MEMORANDUM

TO: Code-Making Panel 5

SUBJECT: NEC® Second Draft FINAL Ballot Results (A2019 Cycle)

(250.34(C)) Revised January 4, 2019

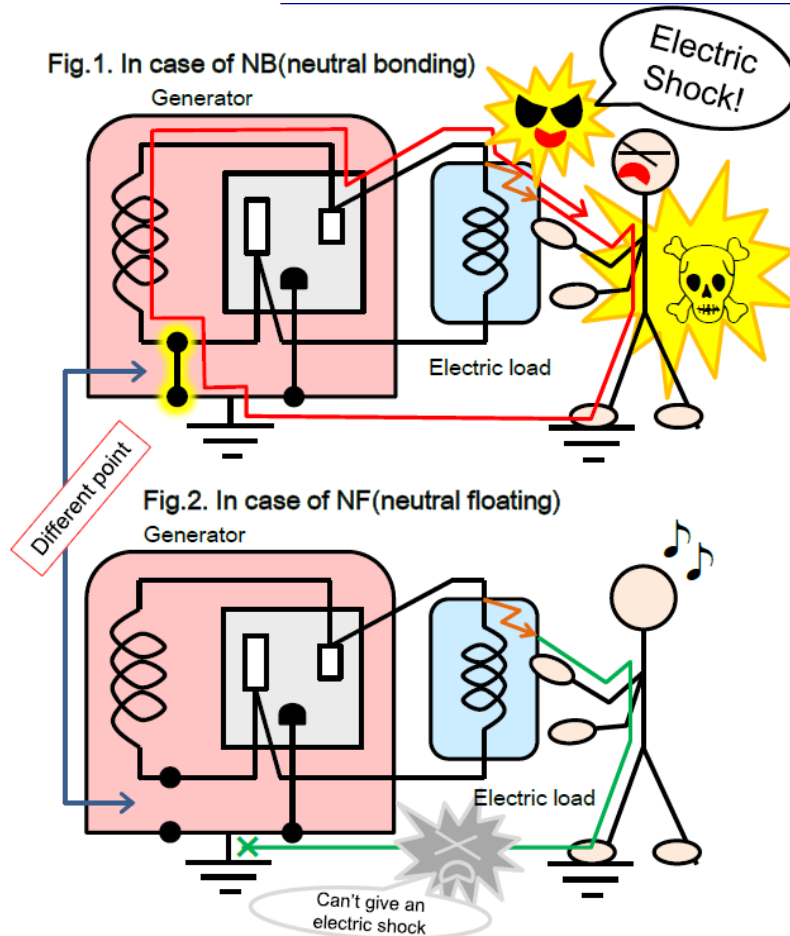
Second revision 7793 would not only require the redesign of all floating neutral portable generators on the U.S. market today, it would make the many millions of floating neutral portable generators in use today unusable in accordance with the NEC, since there is no “effectivity date” for this revision (i.e. it would be retroactive). There is no justifiable reason for making this revision. Floating neutral portable generators are perfectly safe in accordance with the current requirements in NEC 2017. I will explain this further.

There are two typical applications for portable generators. One application is to provide “backup power” to premises wiring systems. Another application is to provide power in “stand-alone” mode, for example at a campsite.

For the backup power application, the portable generator is typically connected to the premises wiring through a transfer switch. In this scenario, the portable generator is part of a grounded system. The only difference between using a floating neutral and a bonded neutral portable generator (in a typical 120/240 V, single phase a.c. system) is that for a floating neutral generator, the neutral conductors of the premises wiring and the generator are connected together (i.e. as a non-separately derived system). The neutral conductor of the floating neutral portable generator is bonded to the equipment grounding conductors of both the premises wiring and the generator through the main bonding jumper of the premises wiring.

For bonded neutral portable generators, the neutral conductors of the premises wiring and the generator are not connected together (i.e. as a separately derived system). The neutral conductor of the bonded neutral portable generator is bonded to the equipment grounding conductor through the bond on the generator itself.
